SUSTAINABLE DEVELOPMENT – URBAN DESIGN & PLANNING

PLANNING & ZONING BOARD (PZB) SITE PLAN APPLICATION

Development / Project Name	1007 EAST LAS OLAS
Development / Project Address	Existing: see address verification New: 1007 E. LAS OLAS BLVD.
Legal Description	see survey
Tax ID Folio Numbers (For all parcels in development)	5042 11 01 0750; 5042 11 01 0760; 5042 11 01 0640
Request / Description of Project	HOTEL DEVELOPMENT (138 rooms; 5,963sf commercial/retail)
Applicable ULDR Sections	Sec. 47-25.3, Sec. 47-28; Sec. 47-20.3.A.5
Total Estimated Cost of Project	\$ 25m (Including land costs)

PROJECT ADDRESS: 1007 E LAS OLAS BLVD, 33301

Figure 1 – City Water Atlas

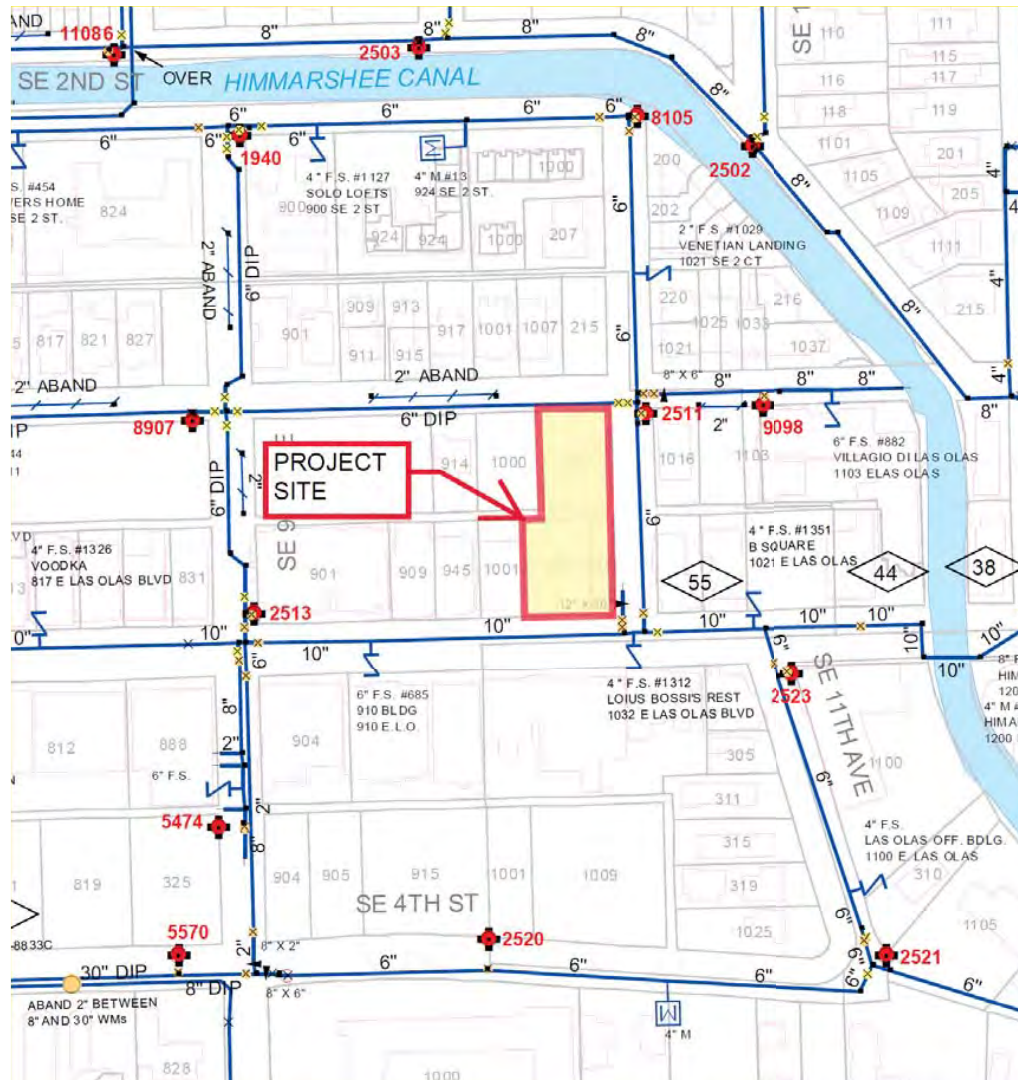
Water: The site is currently served by a 6-inch water main along SE 2nd Court (See Figure 1).

Figure 2 – City Sewer Atlas

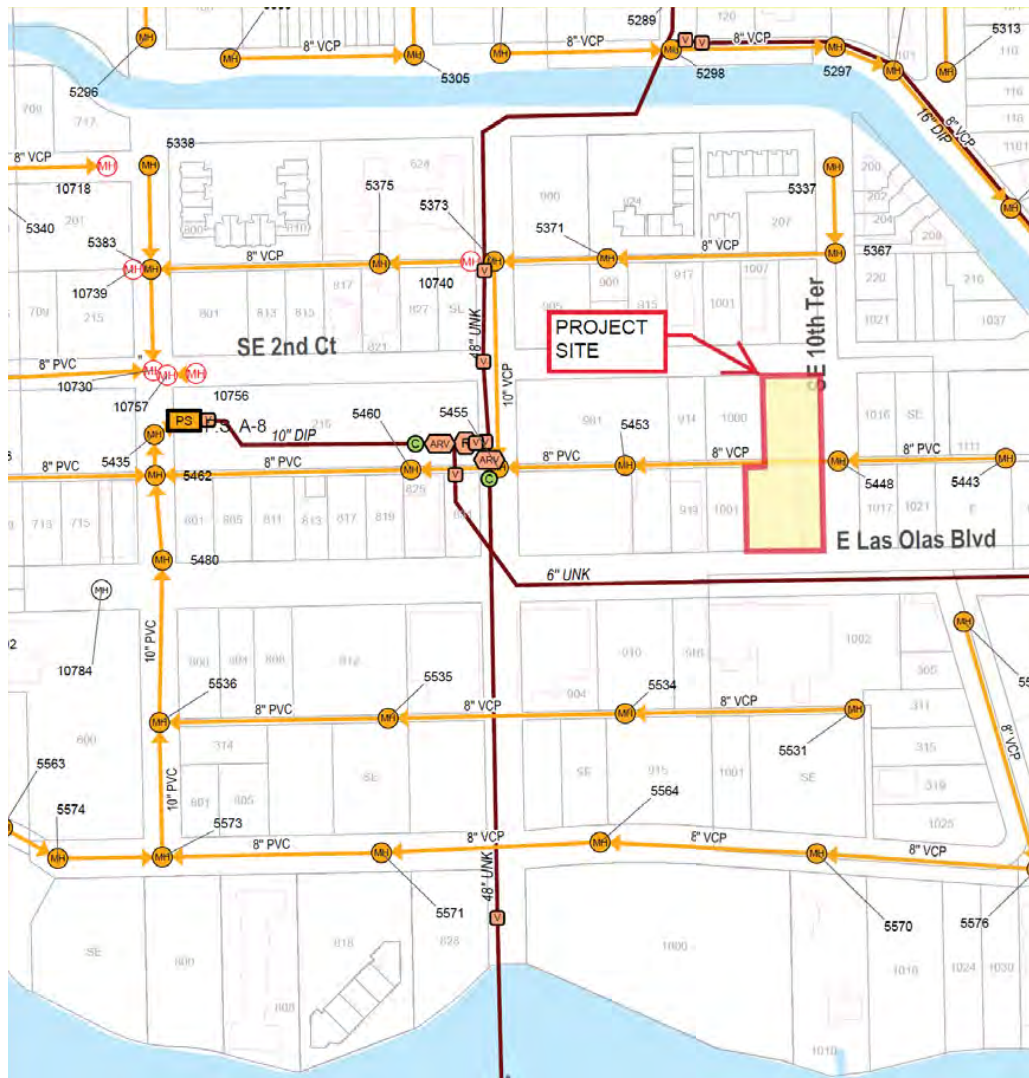
Wastewater: The site is currently served by an existing 8-inch gravity sewer main along the 10' Alley crossing the proposed project site from east to west (See Figure 2).

Figure 3

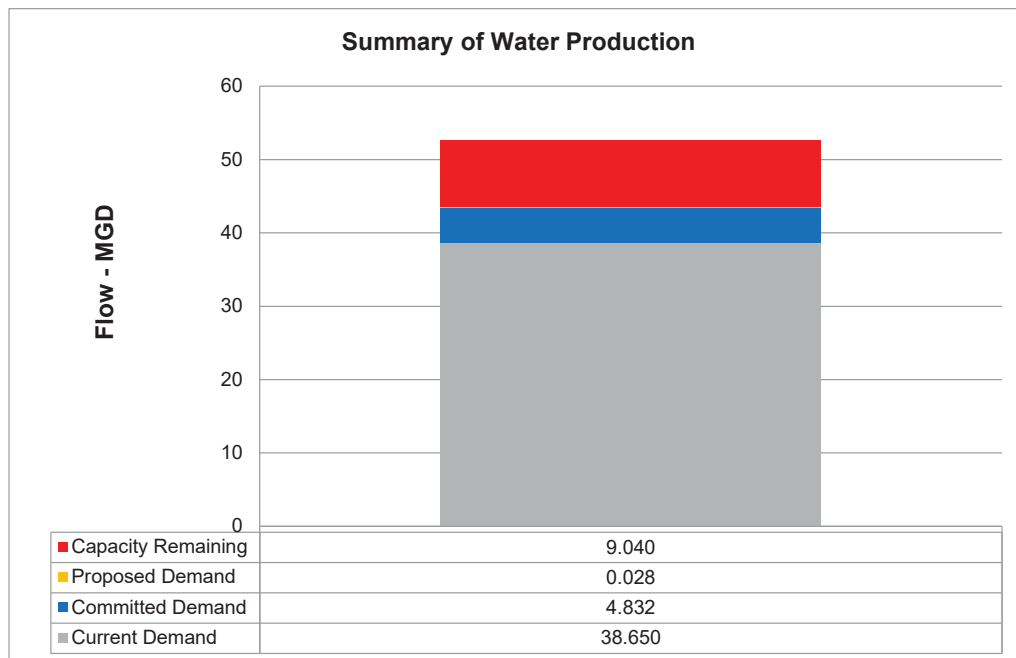
The current twelve-month rolling average production at the two plants is 38.65 MGD. The previously committed demand from development projects in the permitting or the construction stage is 4.832 MGD. Combining these figures with the demand from the proposed project of 0.028 MGD, the required production would be 43.51 MGD. This is less than the allowable withdrawal limit of 52.55 MGD. Therefore, the water plants have sufficient capacity to serve this project. See Figure 3 below.

Recommended Water Infrastructure Improvements: No improvements required.

Figure 4

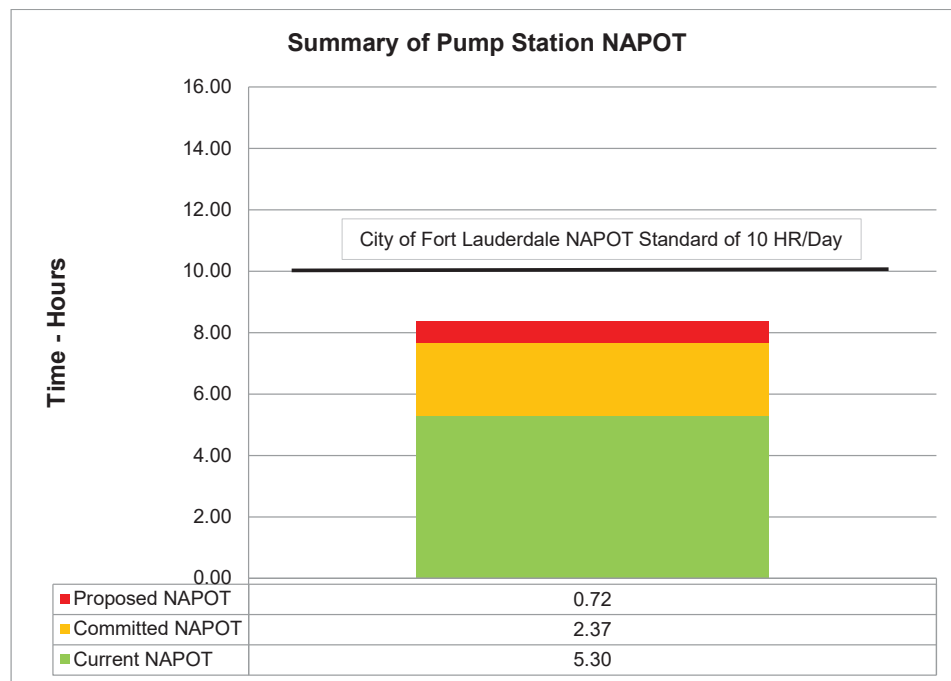
Evaluation of impact on pumping station: PS A-8 has a duty point of 500 gallons per minute (GPM) and has a Nominal Average Pumping Operating Time (NAPOT) of approximately 5.3 hours per day. Based on projected sewage flows, the pumping run times would increase approximately 43 minutes per day. Additionally, there are other committed flows from proposed developments within the PS A-8 basin resulting in approximately 142 minutes of additional runtime at the pump's minimum operating condition. PS A-8 will have a NAPOT of 8.38 hours once the proposed development is completed, less than the recommended average of 10 hours per day (see Figure 4).

Figure 5

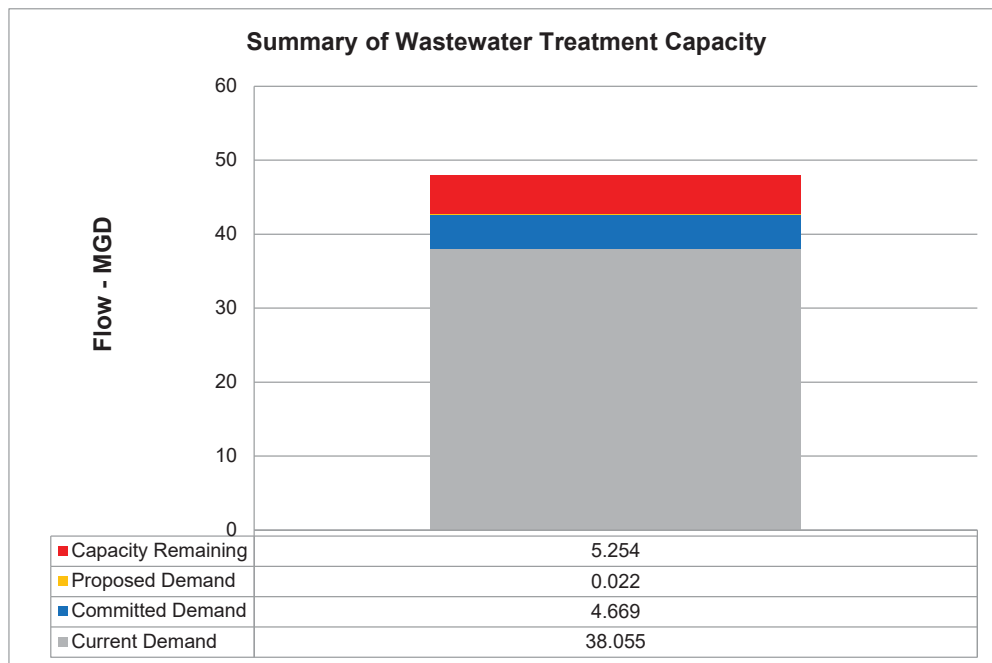
Evaluation of impact of Permitted Wastewater Plant Capacity: The City of Fort Lauderdale owns and operates the George T. Lohmeyer Regional Wastewater Treatment Plant (GTL), which provides wastewater treatment for the City of Fort Lauderdale. The Broward County's Environmental Protection and Growth Management Department's (EPGMD) Environmental Licensing & Building Permitting Division's licensed capacity for GTL is 48 MGD-AADF (Million Gallons per Day – Annual Average Daily Flow). The annual average daily flow (AADF) to the plant is 38.055 MGD. Combining the committed flows for previously approved projects of 4.669 MGD plus the 0.022 MGD net contribution from the project results in a total projected flow of 42.75 MGD. This is less than the permitted treatment plant capacity of 48 MGD. Therefore, the treatment plant has sufficient capacity to serve this project. See Figure 5 below.

Recommended Wastewater Infrastructure Improvements: No improvements required.
